### Power Adjustment Valve Change

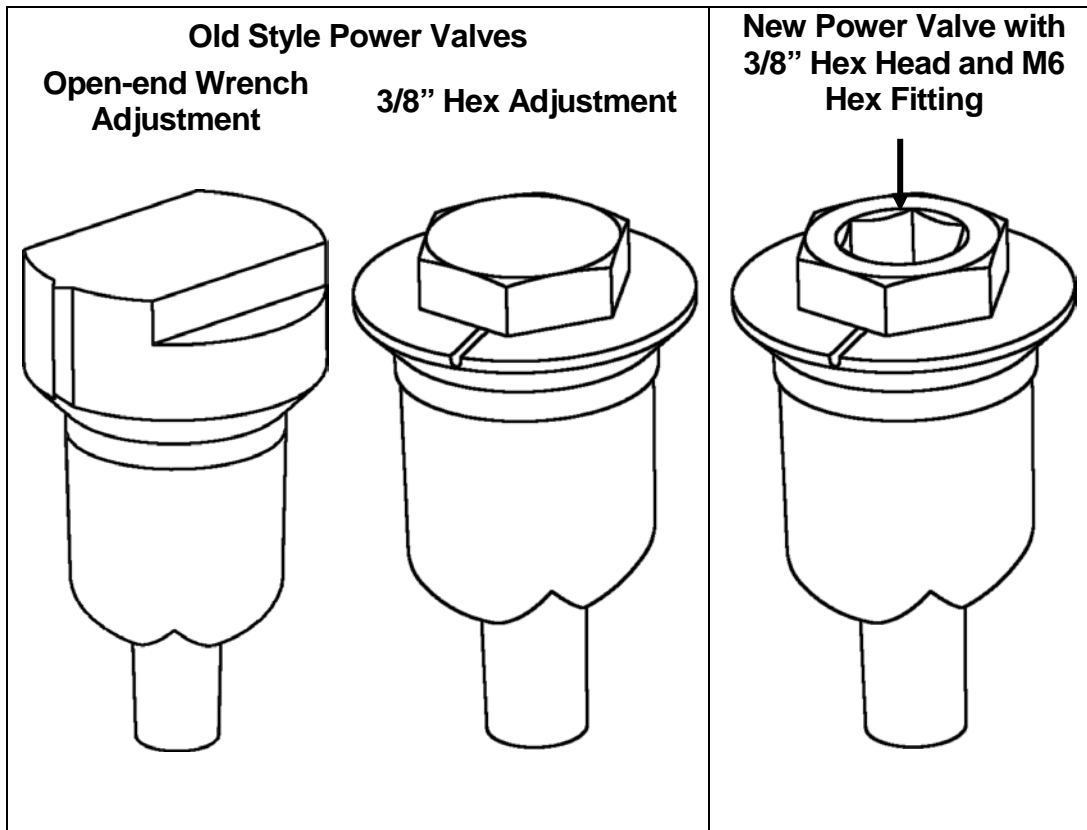
The Power Adjustment Valve in all Series 55 and Adjustable 60 Series Mixers will be enhanced to include an M6 hex fitting in the top, allowing adjustments to be made with either metric or imperial tools. The change is projected to go into effect September, 2007.

The change to the Power Adjustment Valve will affect all 55 and Adjustable Series 60 Mixers (and the Carburetors that utilize these Mixers).
